Nippon Garment Industries Ltd. (Extension)

27 October 2024

2. Observations

Observation 01: Lack of design documents for Warehouse-1.

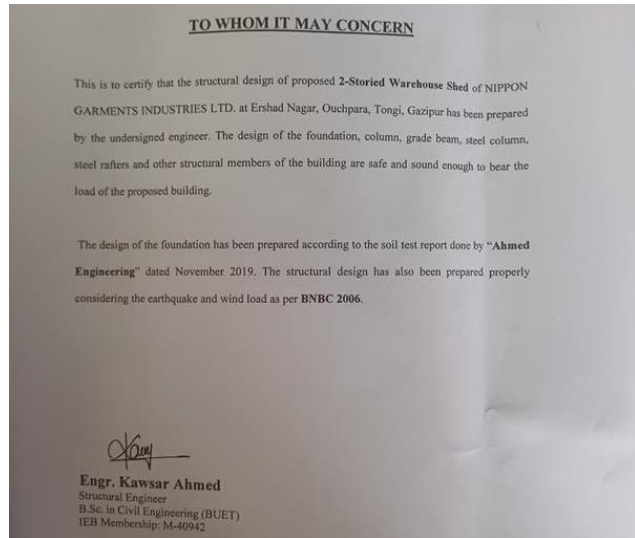
Description: During the inspection, some drawings, a soil test report, and a declaration letter were available onsite. In the declaration letter, the consultant declared that the building is safe and sound enough to bear the proposed load without any reference calculation/design report. The building engineer is required to carry out an Engineering Assessment (EA) to confirm that the building has adequate capacity to bear the gravity & lateral loads as per BNBC-2006. And submit the EA documents to the RSC for detailed review.

SL	Observation	Action Plan	Timeline
1.	Lack of design documents for Warehouse-1.	The building engineer is required to carry out an Engineering Assessment (EA) to confirm that the building has adequate capacity to bear the gravity & lateral loads as per BNBC-2006. And submit the EA documents to the RSC for detailed review.	within 6 weeks

Observation 02: Mismatch between drawing and as-built condition of Warehouse-1

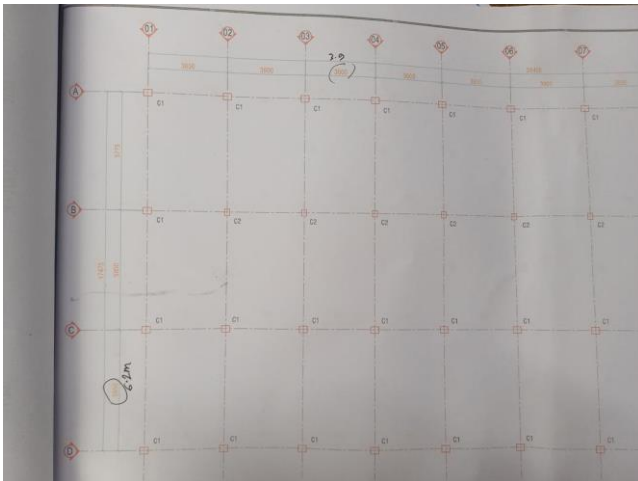
Description: Mismatches in column grid spacing (6.2 m instead of 5.8 m at C-D & 3.9 m instead of 3.6 m at 3-4) were observed. Also, Steel short columns were not shown in the drawings. Furthermore, the steel rafter flange was found slightly more than the drawings (6 mm). The building engineer is required to survey the structures and prepare accurate as-built drawings.

4.	Mismatch between drawing and as-built condition of Warehouse-1	The building engineer is required to survey the structures and prepare accurate as-built drawings.	within 6 weeks

Observation 04: Inconsistency between foundation system and soil test report (recommendation) for Warehouse-1

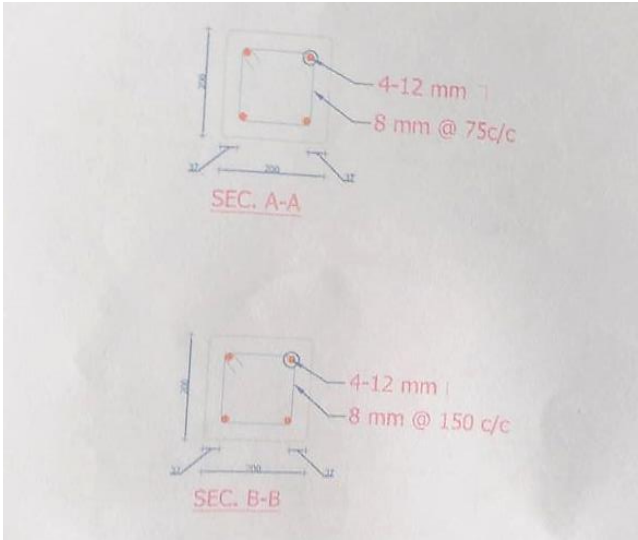
Description: A 500 mm diameter RC cast in-situ pile was prescribed in the recommendation of the report but 250mmx250mm precast pile has been used in the building foundation. The capacity of the precast pile was not determined by any testing/calculation. The building engineer is required to determine the size, length, and capacity of the provided precast pile and calculate the foundation adequacy accordingly.

6.	Inconsistency between foundation system and soil test report (recommendation) for Warehouse-1	The building engineer is required to determine the size, length, and capacity of the provided precast pile and calculate the foundation adequacy accordingly.	within 6 weeks
